RE: Monroe's Restaurant
1025 4th St. NW
Grading and Drainage Plan
Engineer's Stamp Date: 02/11/19
Hydrology File: J14D190

Based upon the information provided in your submittal received 02/12/2019, the Grading and Drainage Plan is approved for Building Permit, Foundation Permit, and Grading Permit.

GRADING PLAN

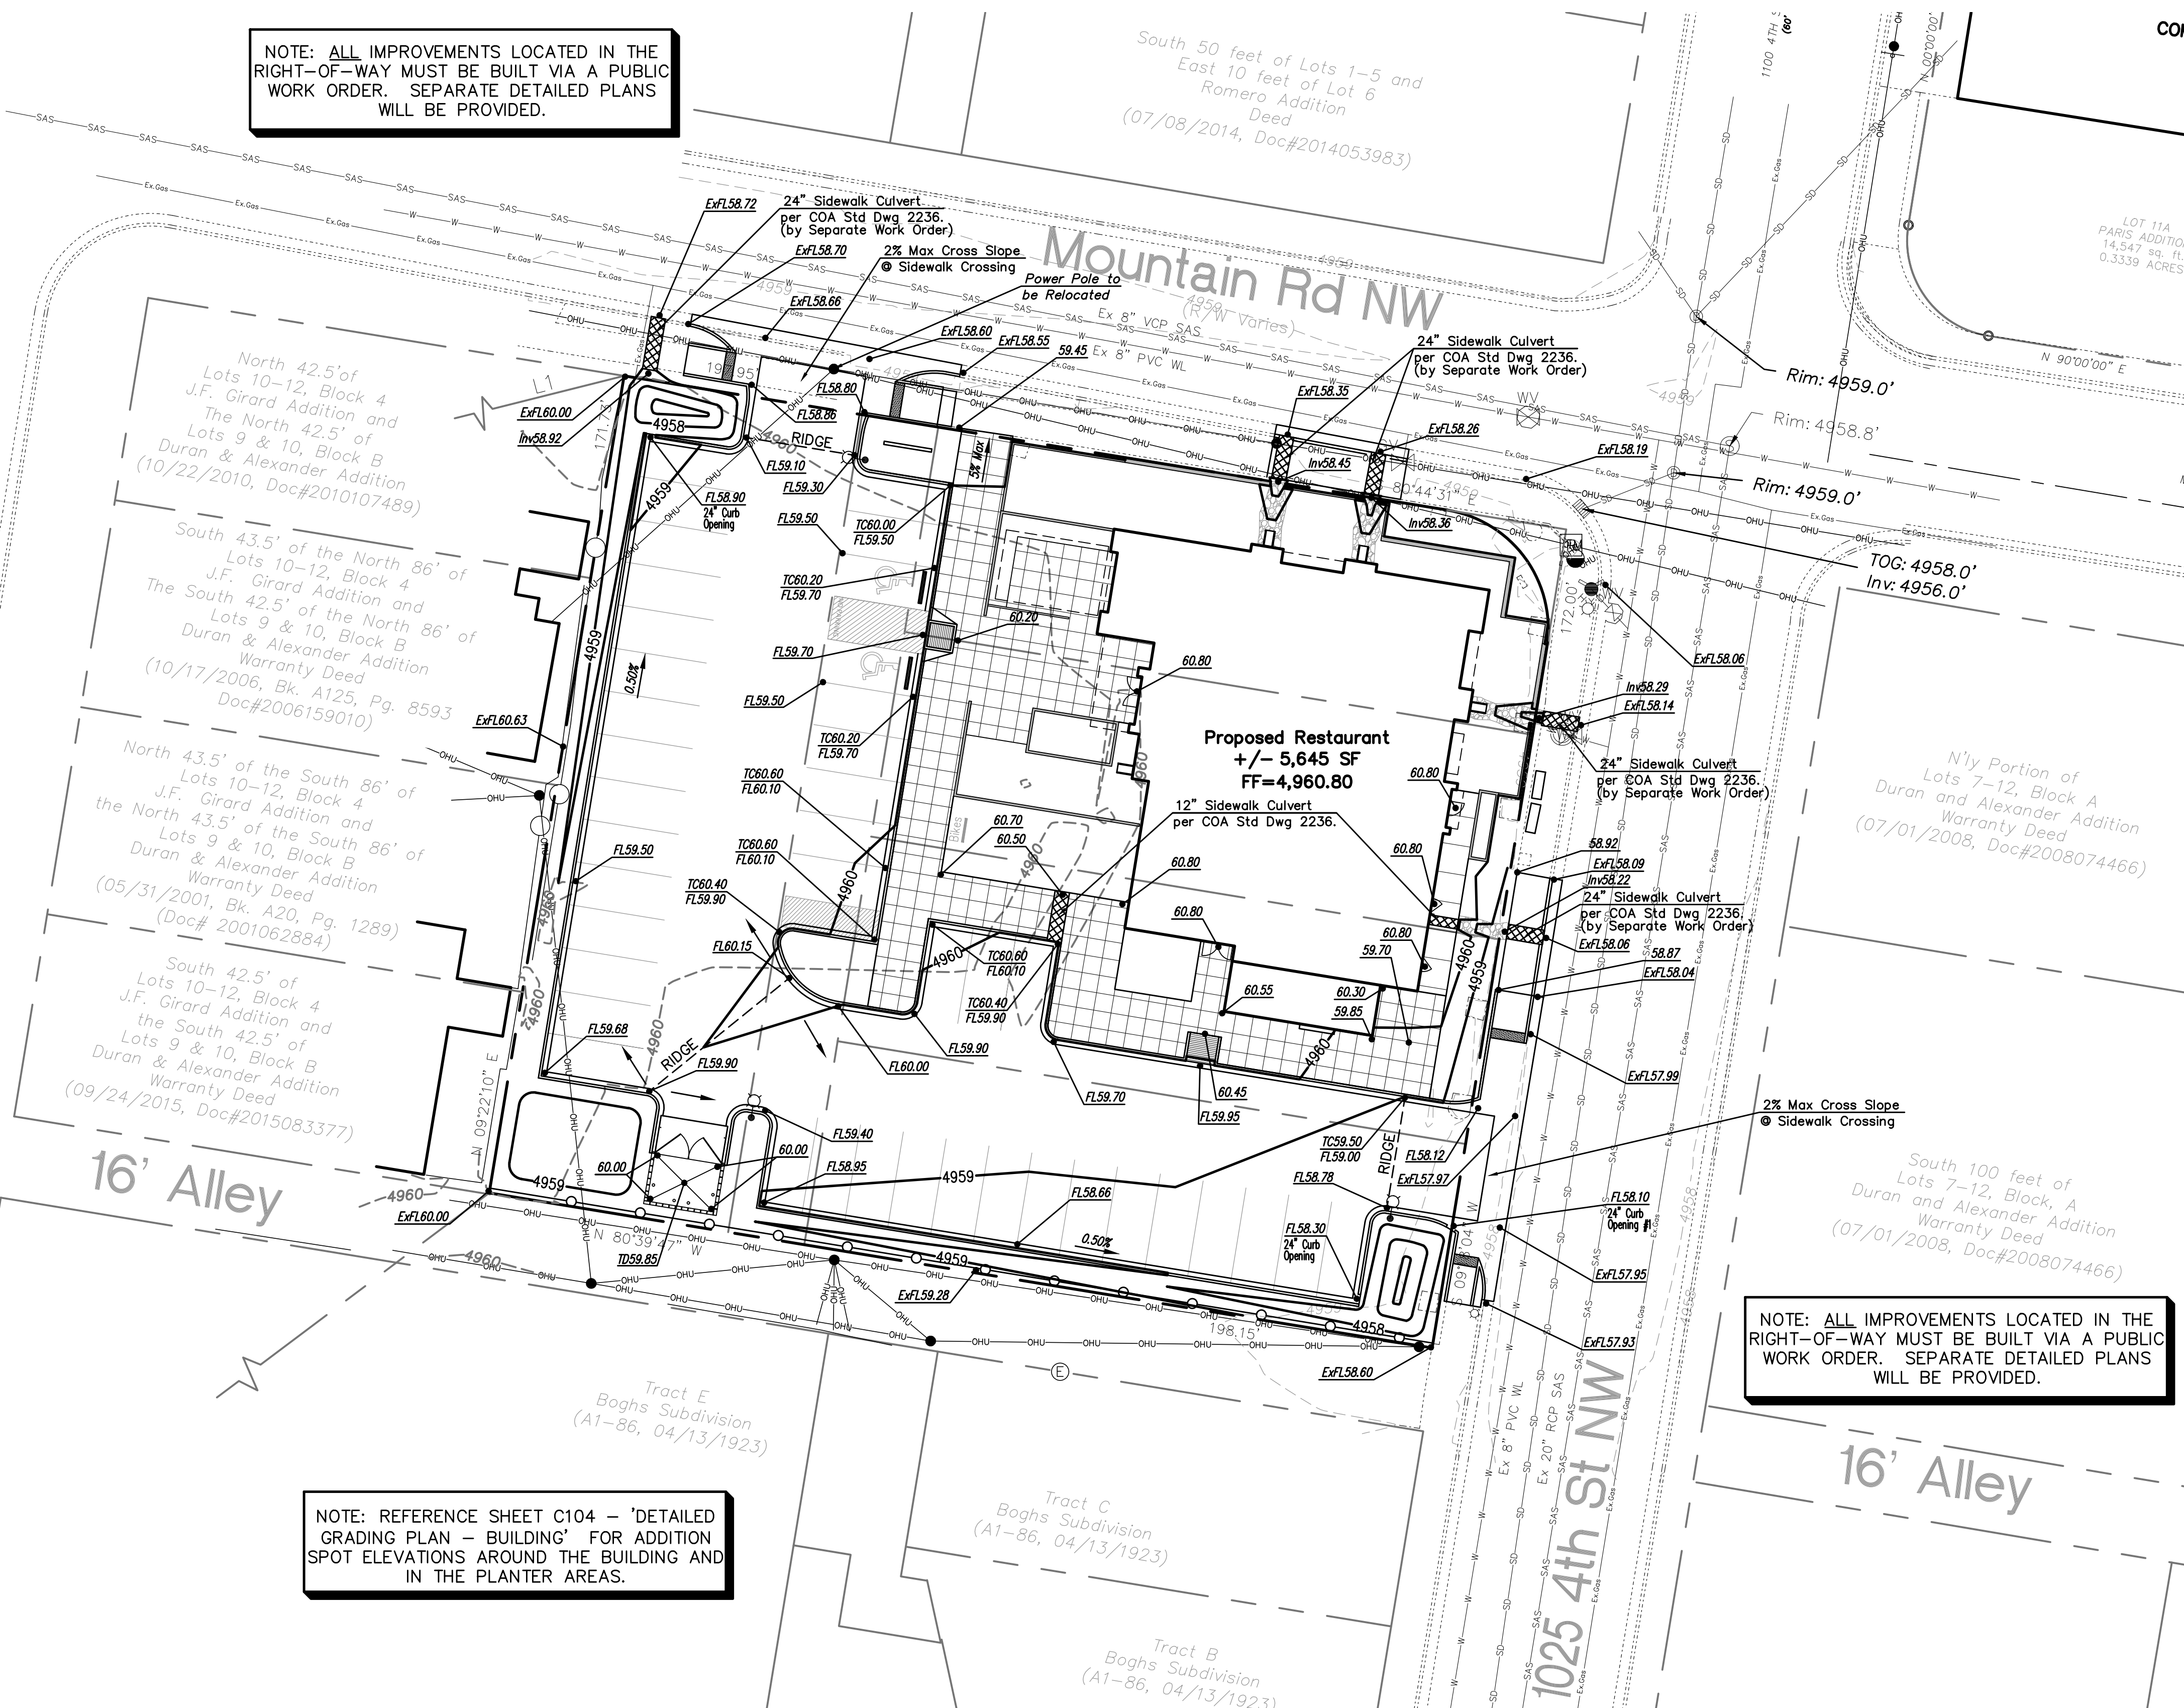
Please provide a Drainage Covenant per Chapter 17 of the DPM for Stormwater Quality ponds and the private storm drain prior to Permanent Release of Occupancy. Please submit this on the 4th floor of Plaza de Sol. A \$25 fee will be required.
